Seagate Technology Tel: 405-324-3070
10323 West Reno (West Dock) Fax: 405-324-3794
Oklahoma City, OK 73127-9705 gene_milligan@notes.seagate.com
P.O. Box 12313
Oklahoma City, OK 73157-2313

Subject: Proposal for revision of the timing tables and definitions in SPI-4

This proposal utilizes the timing budget already accepted into SPI-4 and completes the homework to use the timing budget as the basis for modifying the related timing tables, definitions, and figures. Revision 4 is the result of the working group meeting on 9/12/2000.

Application of timing budget - skew block diagram with post-compensation

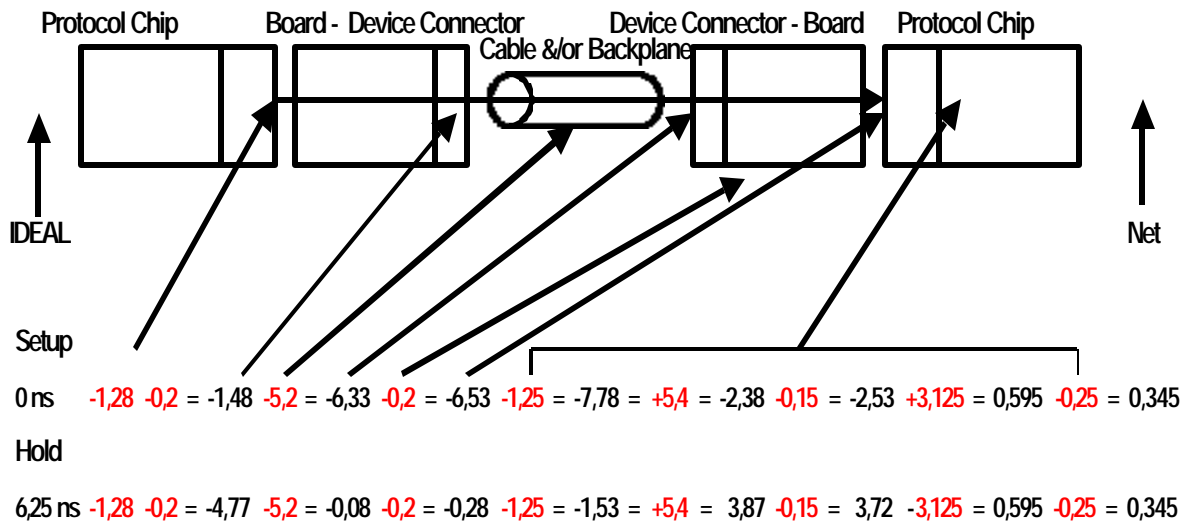
The working group requested that that "Crosstalk" be changed back to "Near end crosstalk". In addition Rev 3 inadvertently included the unchanged Figure for the application of the timing along with the figure with note one changed. Revision 4 deletes the unchanged figure. The ATN requirements will be further changed in a related proposal from Bill Galloway (see 00-343r1).

1) The transmitting SCSI device may reduce the timing margin by the following worse case factors: bit period tolerance (i.e., REQ(ACK) Period Tolerance / 2); driver asymmetry; transmitter chip skew, clock jitter; system noise at launch; and board skew.

2) The transmission of data from one SCSI device to another may have the timing margin reduced by the signal timing skew that comprises the following worse case factors; crosstalk; cable skew; and ISI. If precompensation is invoked the worse case signal timing skew is reduced by the ISI compensation value. Portions of the crosstalk and ISI may also be observable at the transmitting device connector. Consequently transmit setup and transmit hold time should be measured with an alternating pattern at the negotiated data rate with all data signals other than that being measured held at a continual assertion or negation.

3) The reception of data within a SCSI device may have the timing margin reduced or increased by the following additional worse case factors: board skew; receiver amplitude time skew; receiver chip skew; receiver time asymmetry; system noise at the receiver; receiver chip noise (applied at receiver due to small signal physics); ISI compensation; skew compensation; strobe offset tolerance; and residual skew error.
